**City of Concord Planning Board  
August 19, 2015**

**Project Summary Sheet  
Major Site Plan**

*Project Name:*           **O'Reilly Auto Parts (2015-30)**  
*Owner:*               **O'Reilly Auto Enterprises, LLC**  
*Address:*             **189 Fisherville Rd.**  
*Map/Block/Lot:*      **204P/73**

**TO:** Community Development  
**FROM:** Laura M. Aibel, PE, Associate Engineer  
Jeffrey A. Warner, PE, Project Manager/Civil Engineer  
**DATE:** August 6, 2015  
**SUBJECT:** Site Plan review for O'Reilly Auto Parts; Map 204P, Lot 70

### 1 SITE DEVELOPMENT PLAN

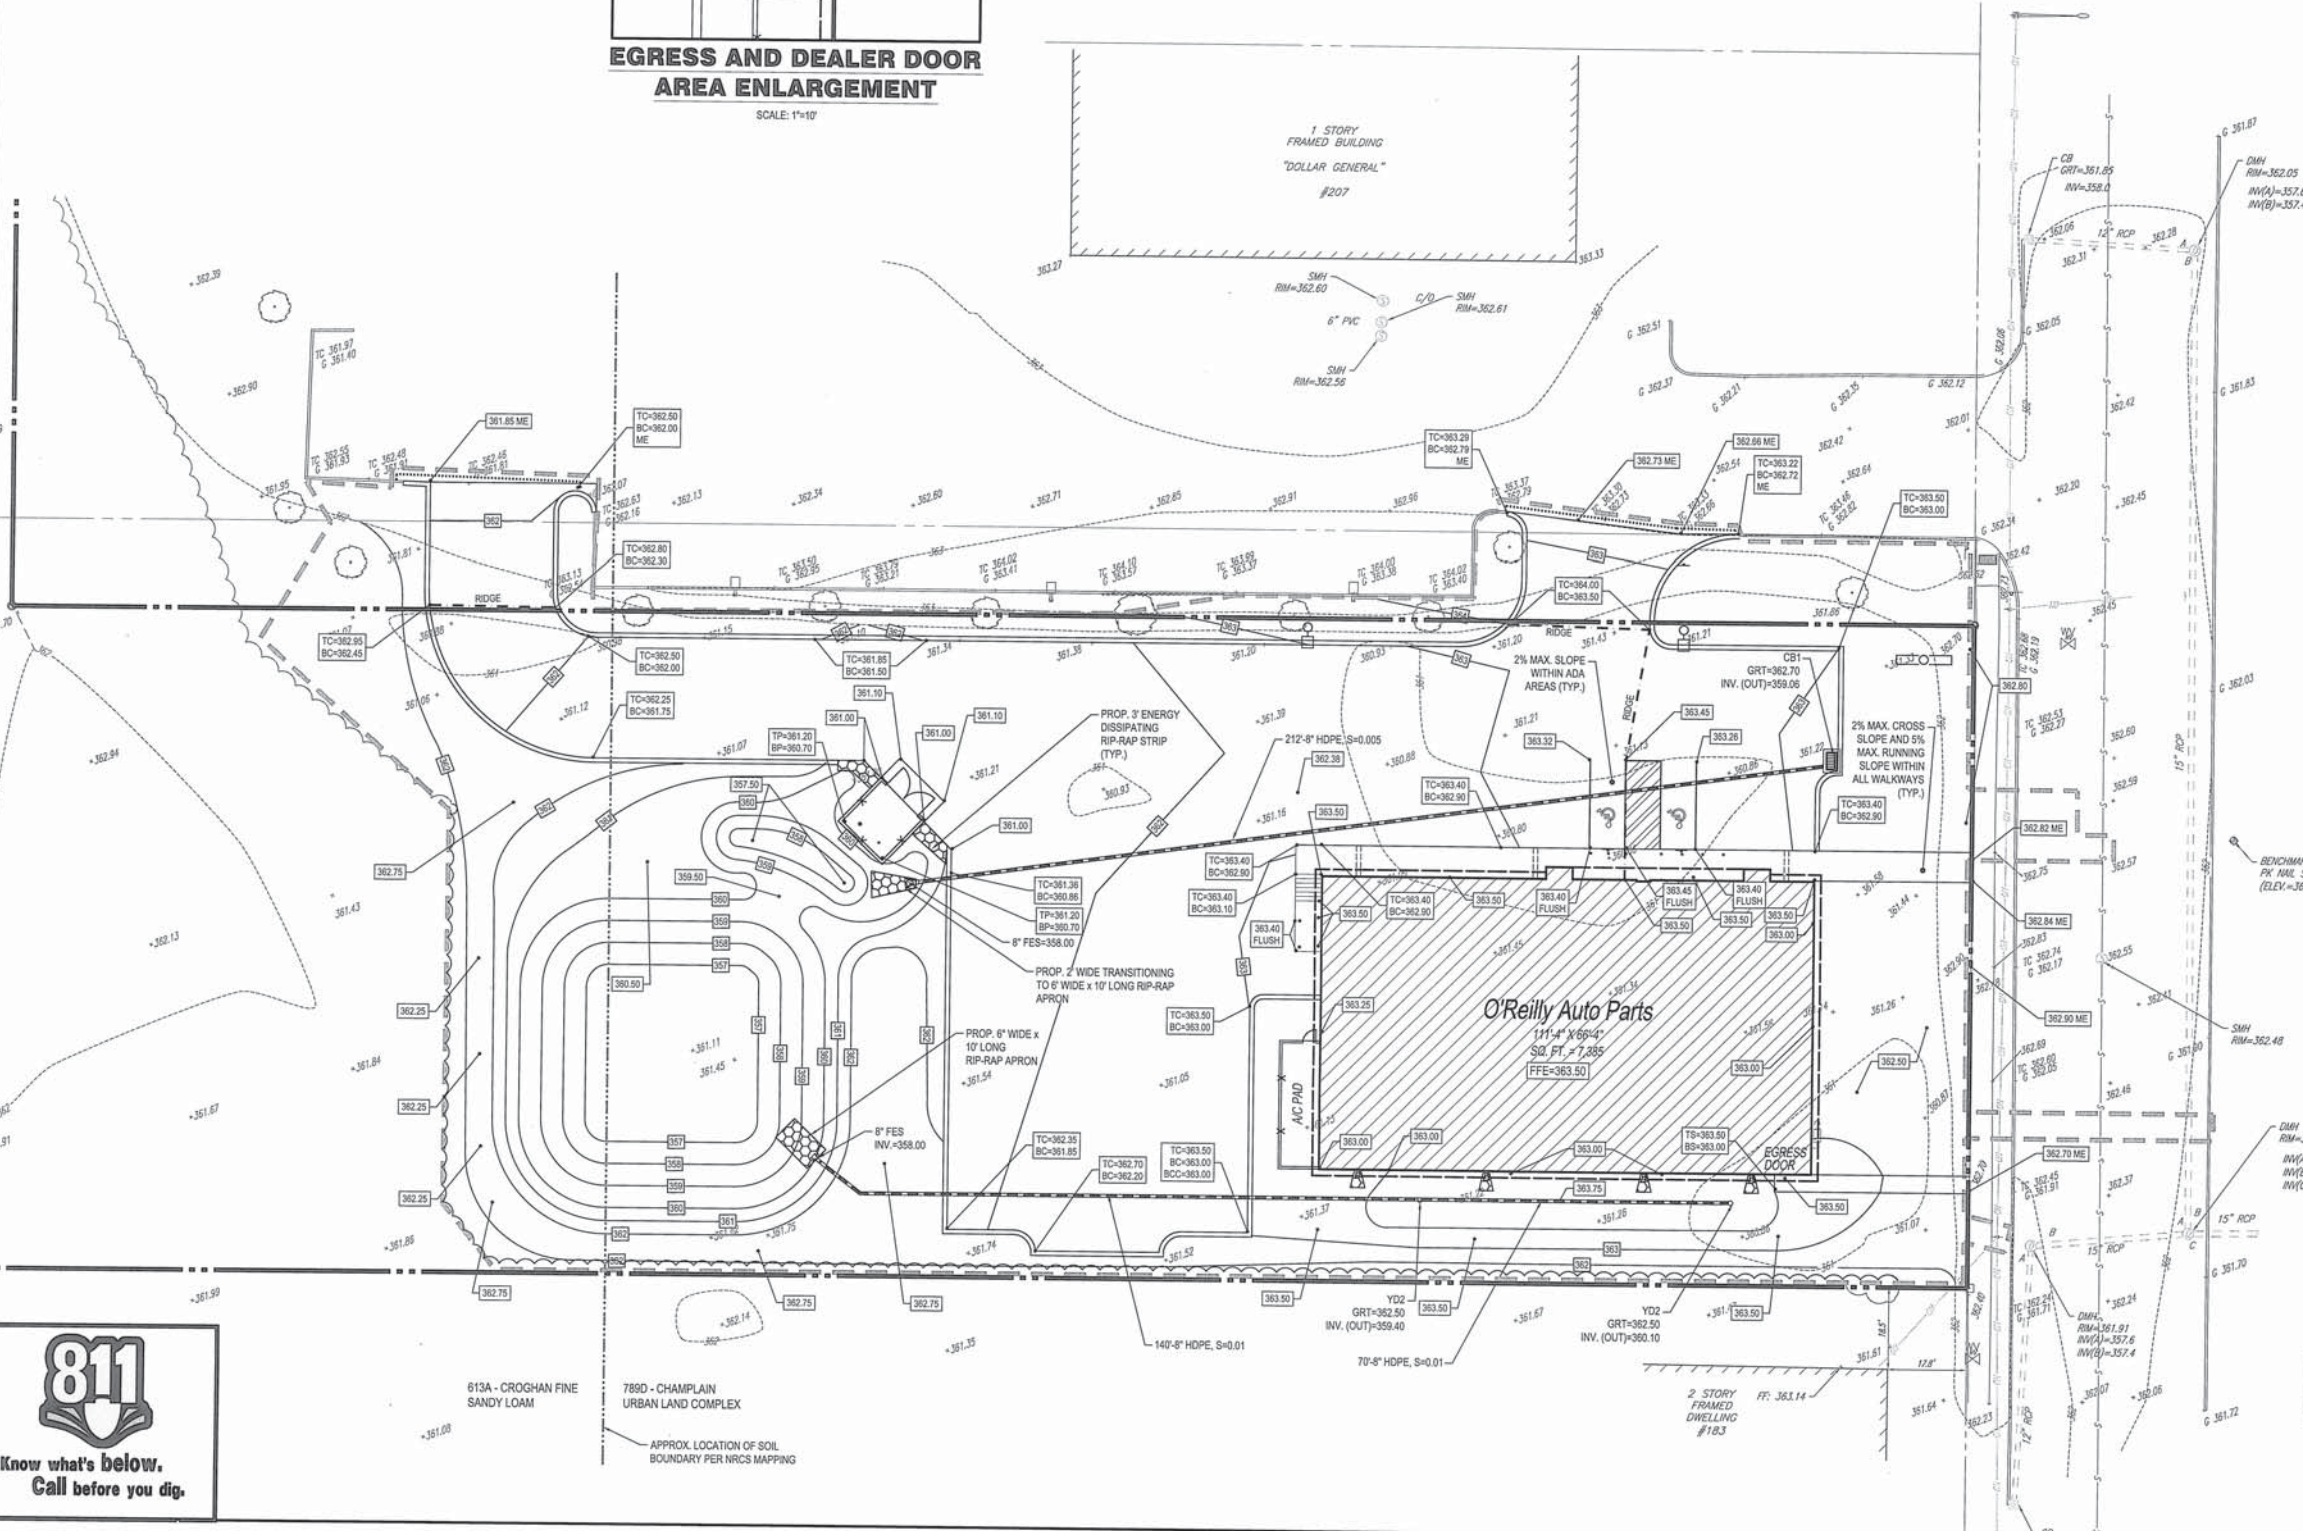
1. Consistent with the 2010 Bicycle Master Plan, bicycle parking should be provided as close to the main entrance as practicable. The preferred rack design is an inverted "U" similar to the "Square U Rack" by MADRAX or the Downtown Rack by Dero, or a post and ring type rack where the center post is the same dimension as the ring dimensions. As noted by the Pedestrian and Bicycle Information Center (administered by the Pedestrian and Bicycle Information Center (PBIC) within the UNC Highway Safety Research Center and funded by the Federal Highway Administration), "The availability of safe and convenient parking is as critical to bicyclists as it is for motorists, yet it is frequently overlooked in the design and operation of shops, offices, schools, and other buildings."

PBIC directs designers to the 2010 Bicycle Parking Guidelines published by the Association of Pedestrian and Bicycle Professionals (APBP) for guidance. For short term parking, this guide recommends 1 space for each 5,000 sf of floor area, minimum 2 spaces. We suggest one rack be placed to the east of the parking area near the northeast corner of the building on a 6'x8' concrete pad.

2. In accordance with Construction Detail M-12 and 13, dumpsters shall be located a minimum 25' from any drainage structure, inlet or stormwater facility.
3. We believe all the striping in the parking lot (including symbols) should be white except for the striping between opposing traffic. The goal is uniformity in what drivers see no matter where they are. The following is an excerpt from the MUTCD.

## 1 LANDSCAPE PLAN

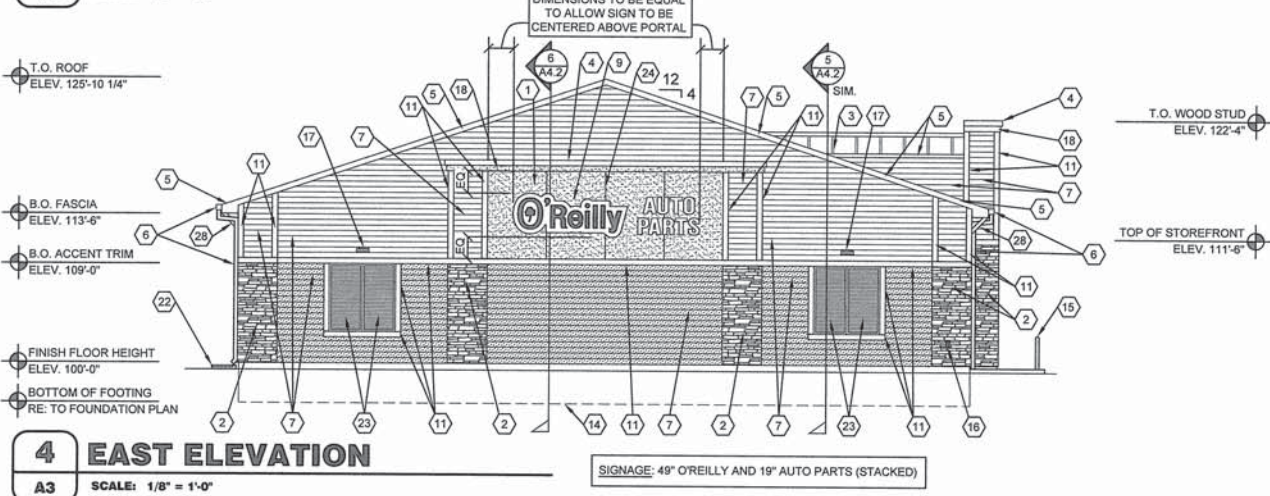
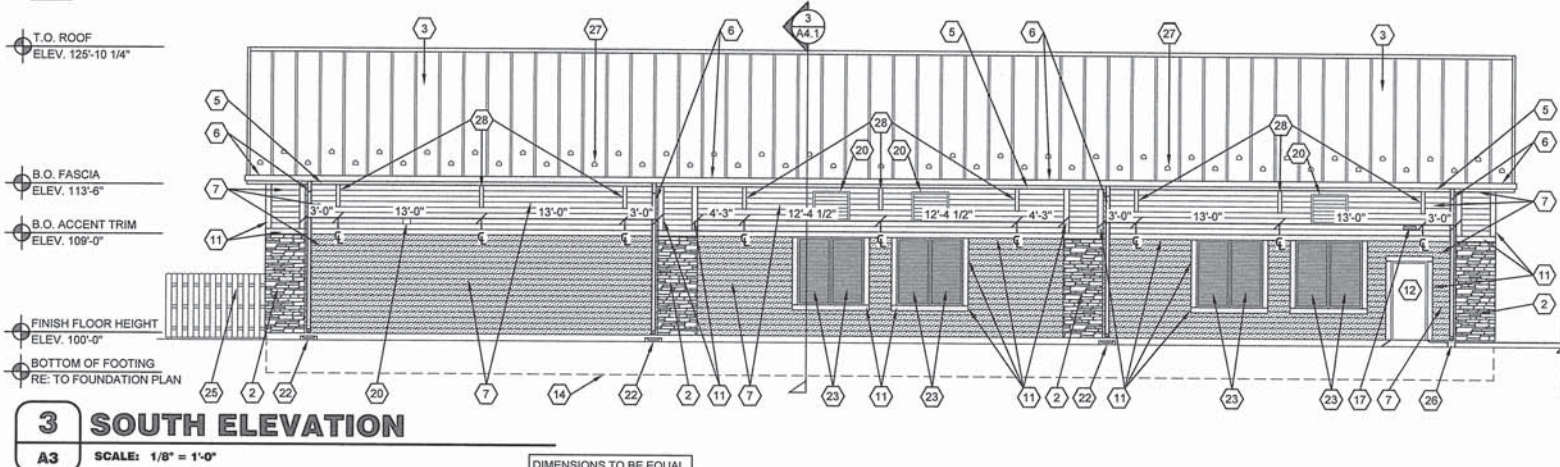
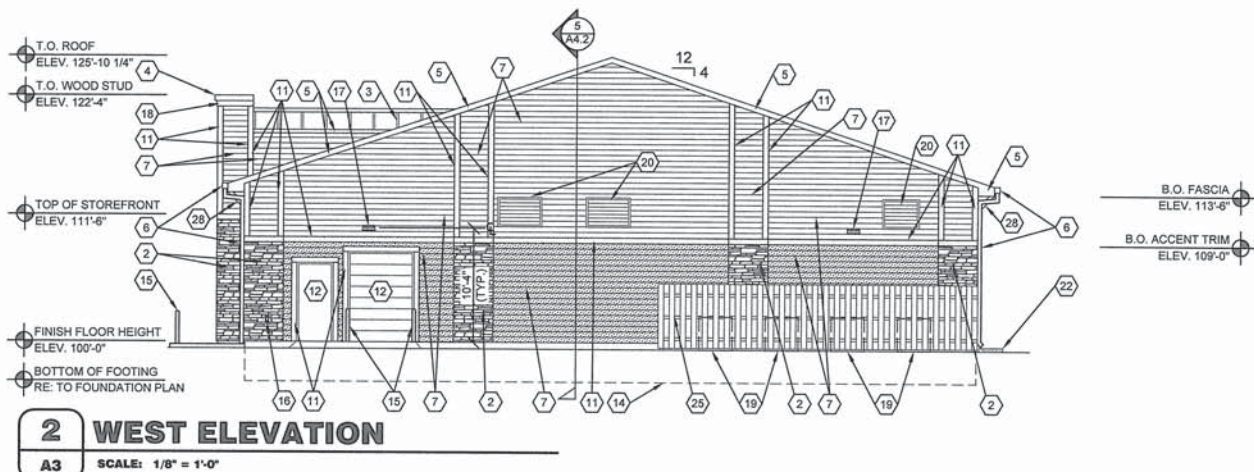
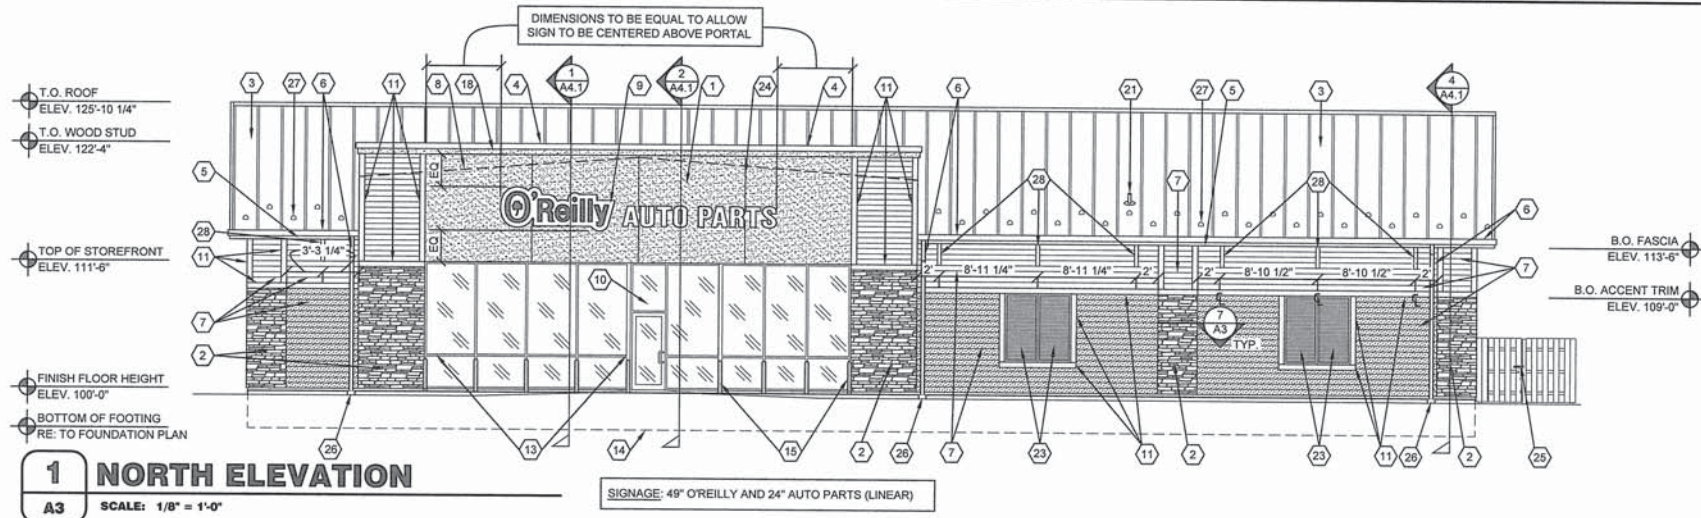
- C.1 Please note that Section 28-7-7(g) (ZO) requires a 10-foot wide parking setback from collector roads, while Section 28-7-10 (ZO) requires a 10-foot landscape buffer around the perimeter of parking areas when the parking setback requirement is 10 feet.

Site Plans and Landscape Plans should be revised to indicate the 10-foot parking setback from Fisherville Road, and to provide the 10-foot wide landscape buffer around the perimeter of the parking lot. The landscape buffer shall include shrubs, trees, and groundcovers. The proposed plan indicates grass and trees. Shrubs and groundcovers shall be provided, including along the eastern perimeter of the parking area, which fronts on Fisherville Road.

- C.2 According to Section 18.17 of the Site Plan Regulations (SPR), required parking lot trees must be planted within 20 feet of the parking lot. The applicant is proposing the required quantity of trees, however, five (5) of these are not located within 20 feet of the parking area.

- C.6 The Landscape Plan must show existing trees to remain. Currently, the Landscape Plan indicates two (2) proposed trees in the same location that two (2) existing trees are indicated to remain on the Demolition Plan.

1. The plan calls for "detention basin seed mix (typ)". See previous comment regarding the detention basin bottom. Will this seed mix flourish in conditions where it will be inundated for 72+ hours and arid conditions or should a pea stone surface be used?
2. The shrubs around the sign are within three feet of the sidewalk. These shrubs will be within a zone where they may be impacted by snow removal from the sidewalk. Five feet of separation is recommended. Are the plants appropriate for this location or should a perennial which dies back in the fall be more appropriate?

## 1 SL2 SITE LIGHTING PLAN SCALE: 1"=20'

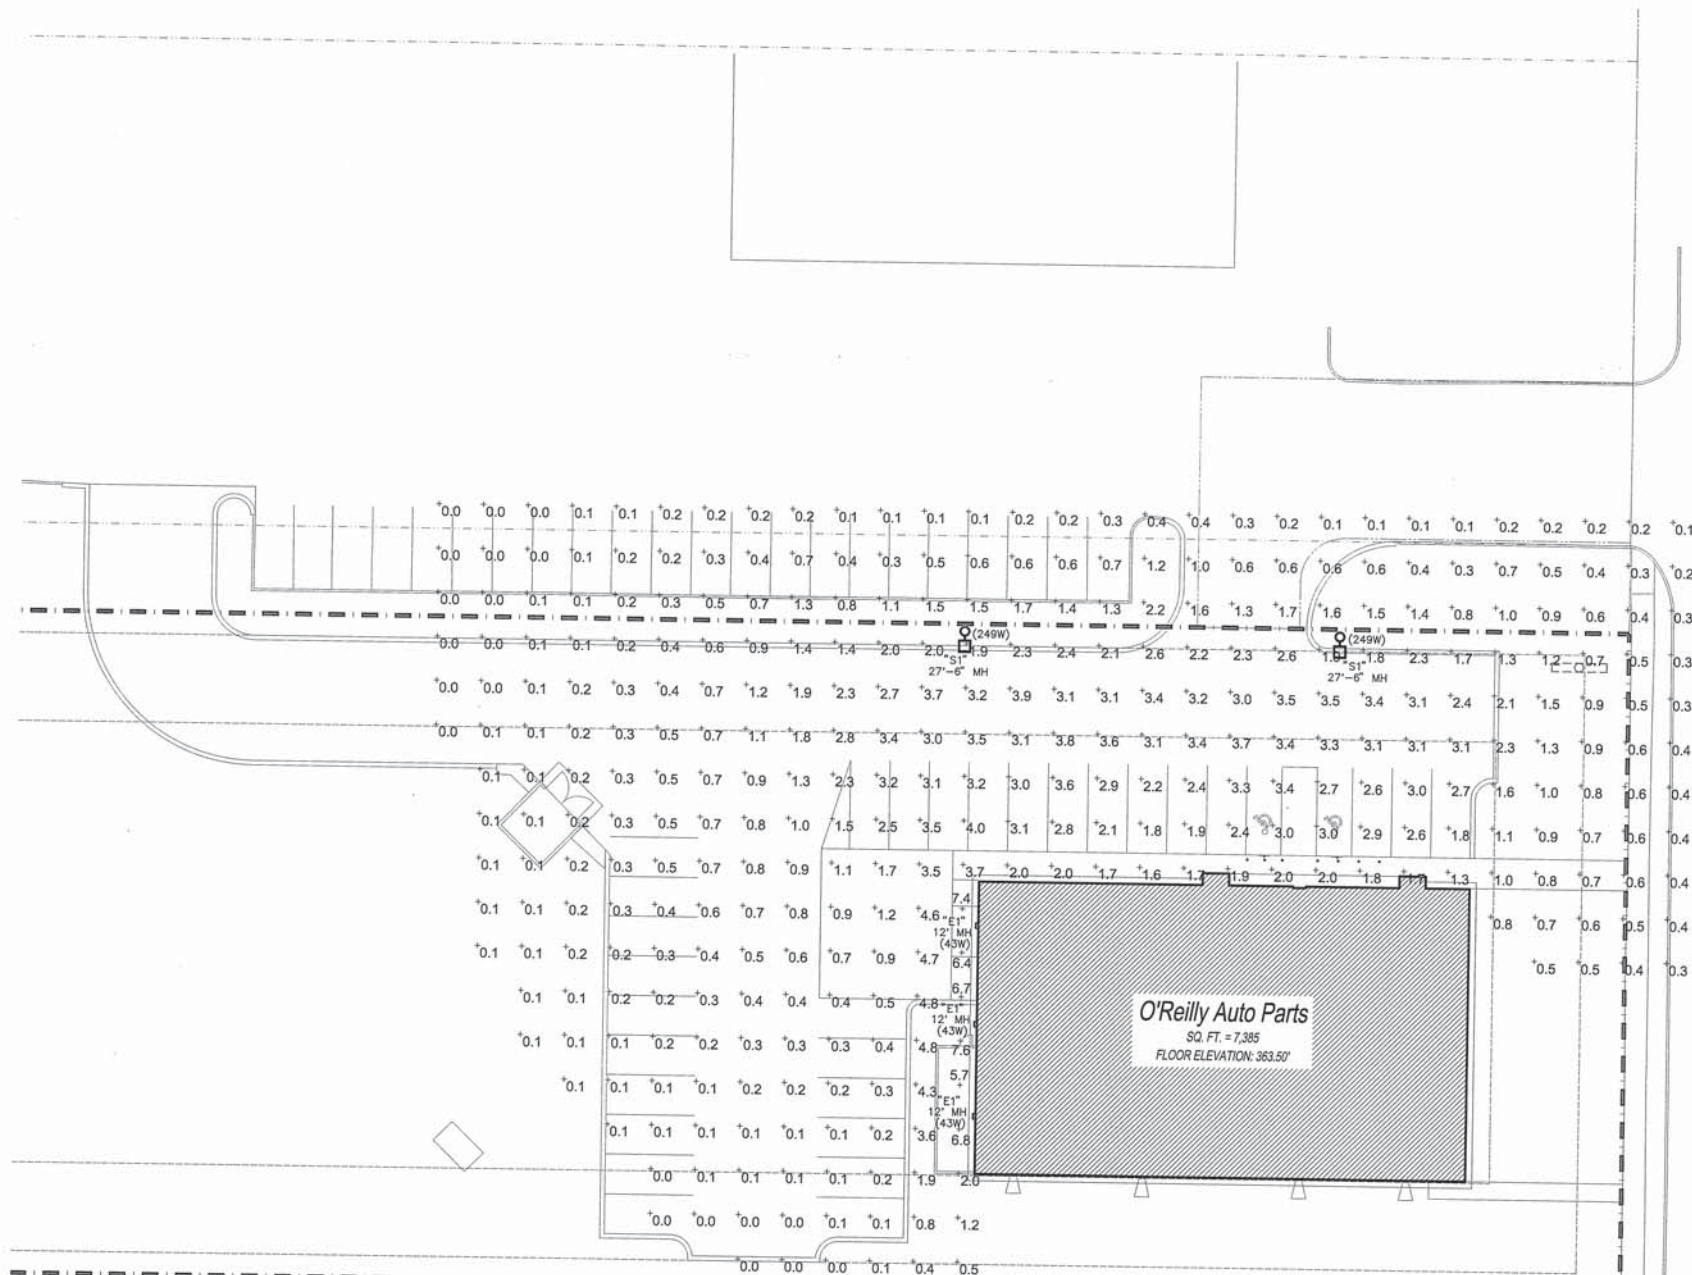
1. The details indicate a 2'-6" foundation height. Since the poles are located well behind curb, the foundations should be limited to 6" of exposed concrete above finish grade.

2. What is the BUG rating for the wall mounted fixtures?
3. The mounting height of the Type "S1" fixtures is noted as 27'-6" which exceeds the maximum allowed fixture height of 25'.

4. It is unclear which "S1" fixture is to be used for this site.
5. Using the contemporary standard set by the Model Lighting Ordinance (June 15, 2011; Illuminating Engineering Society of North American and International Dark Sky Association), we recognize this neighborhood as LZ-2, Moderate ambient lighting. As such, based on the BUG rating, the maximum uplight should be limited to U2 and the glare should be limited to G2. The "S1" fixture appears to have a G3 or G4 rating which is more appropriate for a downtown location.

6. Per Concord Zoning Ordinance 28-7-7(j), all parking lot illumination shall be subject to a four to one uniformity ratio, which is the ratio of the average illumination to the minimum illumination. The designed uniformity ratio, and the average, maximum and minimum lighting levels should be noted on the plans for the parking areas. A line or shading should be added to the plan to indicate the area used in the calculations.

7. Building mounted lighting should be included in the lighting calculations. The building elevations indicate that fixtures will be installed on the south, west and east side of the building. The footcandle distribution should include these fixtures. Also, any lighting proposed under the overhang at the entrance should be included in the calculations.
